PROJECT TITLE  
 NEW THARWA LOOKOUT INCLUDING  
 NON POTABLE WATER FOR FIRE FIGHTING PURPOSES  
 TYPICAL SECTIONS  
 SHEET 1

The Environment and Planning Directorate (EPD) has engaged Calibre Consulting to undertake a non-potable water supply options study to meet the fire fighting and/or domestic demands for Tharwa Rural Village (including Cuppacumbalong). The study area, as shown in **Figure 1-1**, is bounded by part Block 4 Section 27 to the north, part Block 8 Section 13 to the west, Block 4 Section 12 to the south and the river corridor to the east.

SHED - ELEVATION LOOKING WEST  
SCALE 1:75

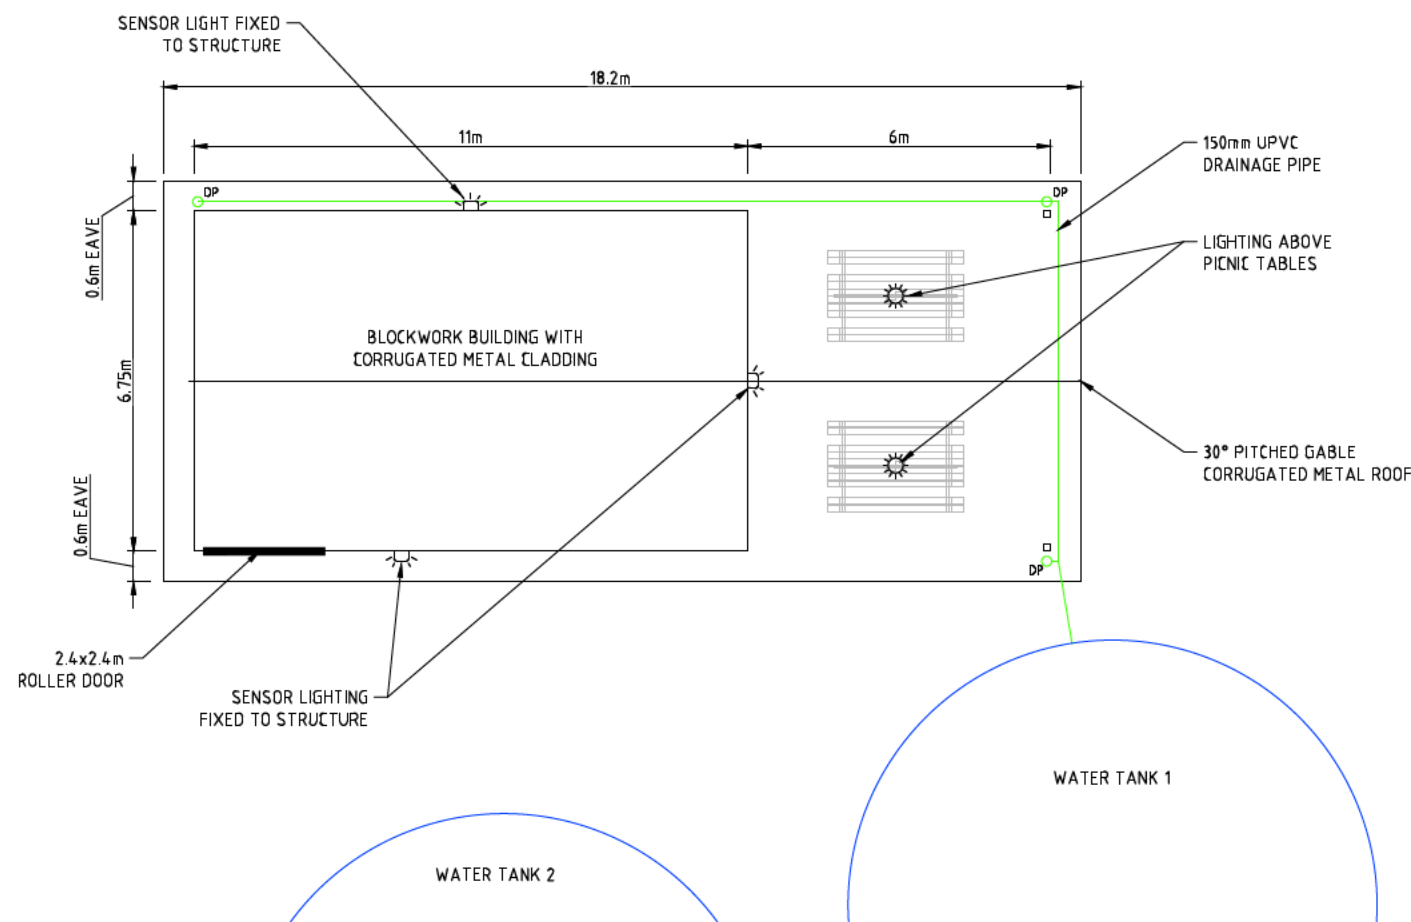
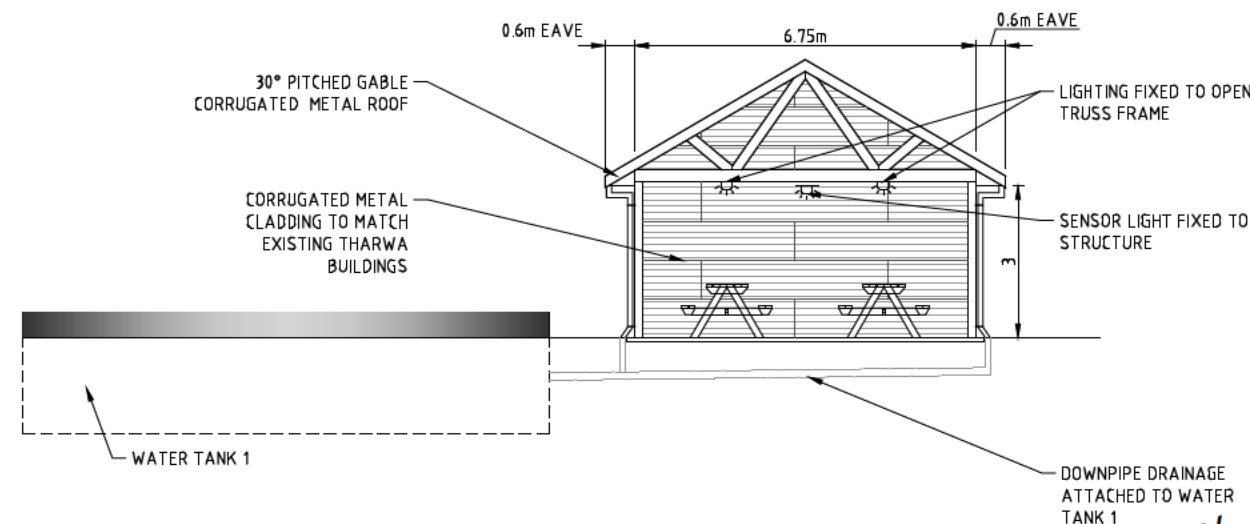
- The proposed building design, materials and finishes for the new pump house building/picnic area need to respond to Tharwa Village Design Guidelines in order to achieve the desired character for new buildings in Tharwa Village. In order to achieve this the following should be addressed:
  - The proposed roof design should incorporate the following:
    - Eaves and gables at the roof ends to provide a traditional rural character;
    - Inset upright posts for eaves at the picnic area roof end;
